Application No.	Applicant(s)				
Office Action Comments	10/573,099	LIU, LAISHENG				
Office Action Summary	Examiner	Art Unit				
	DAVID EASTWOOD	3731				
The MAILING DATE of this communication appears on the cover sheet with the correspondence address Period for Reply						
A SHORTENED STATUTORY PERIOD FOR REPLY IS SET TO EXPIRE 3 MONTH(S) OR THIRTY (30) DAYS, WHICHEVER IS LONGER, FROM THE MAILING DATE OF THIS COMMUNICATION.  - Extensions of time may be available under the provisions of 37 CFR 1.136(a). In no event, however, may a reply be timely filed after SIX (6) MONTHS from the mailing date of this communication.  - If NO period for reply is specified above, the maximum statutory period will apply and will expire SIX (6) MONTHS from the mailing date of this communication.  - Failure to reply within the set or extended period for reply will, by statute, cause the application to become ABANDONED (35 U.S.C. § 133). Any reply received by the Office later than three months after the mailing date of this communication, even if timely filed, may reduce any earned patent term adjustment. See 37 CFR 1.704(b).

### **DETAILED ACTION**

Fig. 3

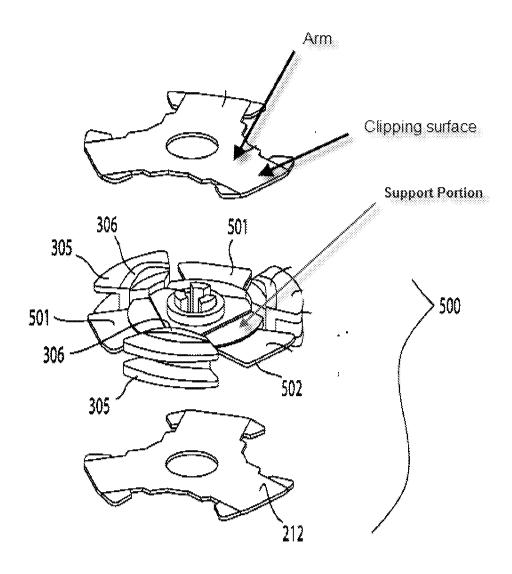
shaft (214) and a set of single-pieces (500), said arcuate shaft being supported on a shaft seat (201) of the main body (11), a first stage gear of said reduction gear set being meshed with a driving wheel of said motor (203,204), a last stage gear being fixed on the single-piece which is located at the endmost position (208), each single-piece having at least one arm (portion of clipping surface 212 which connects to the through bore in the center of the single piece component see figure below), each arm having a clipping surface (212) and a supporting portion (see figure below.) provided at a surface of the arm opposite to the clipping surface (212).

Applicant alleges that Yiu fails to disclose the clipping surface and the support portion are formed on the same arm of the single-piece and are opposite to each other. The examiner respectfully disagrees. Once assembled the single piece 500 has a support structure (see figure above) formed (once assembled) to an arm of the clipping structure (212) (see figure 3 and above).

Applicant goes on to argue that Yiu fails to disclose each single-piece having at least one arm, each of the arms having a clipping surface and a supporting portion provided at a surface of the arm opposite to the clipping surface, the whole set of single-pieces being arranged in such a manner that the clipping surfaces are directly opposite to each other, a clipping gap being formed between opposite surfaces of the arms of two single-pieces. The Examiner respectfully disagrees. Yiu does disclose each single-piece having at least one arm (see figure above), each of the arms having a clipping

surface and a supporting portion provided at a surface of the arm opposite to the clipping surface (see figure above and the aforementioned argument), the whole set of single-pieces being arranged in such a manner that the clipping surfaces are directly opposite to each other (see aforementioned argument), a clipping gap being formed between opposite surfaces of the arms of two single-pieces (see aforementioned argument).
